1993 Corvette: Service Bulletin: Hood Will Not Open - Cable Disconnection

Subject: HOOD WILL NOT OPEN, CABLE DISCONNECTED

Bulletin Number: 93-151-10

TOOL

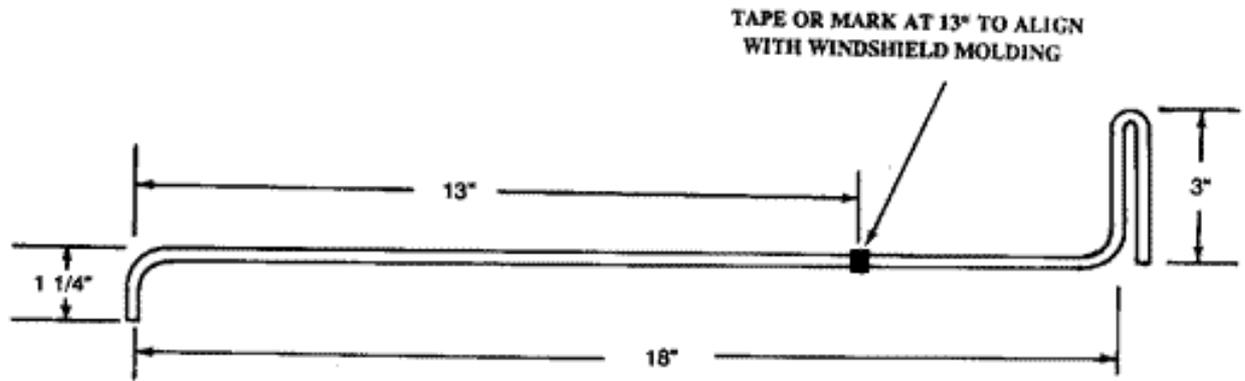
- Obtain material locally and fabricate the tool shown on the illustration from 3/16" or 1/4" steel rod.
- With the door open, locate the short bent end of the tool inboard of the vertical flange of the hood latch support.
- insert the tool forward until the tape is aligned with the lower end of the windshield pillar molding.
- Twist the tool to contact and move the latch lever until the latch disengages. A slight downward pressure on the hood in the latch area may be helpful to disengage the latch lever.
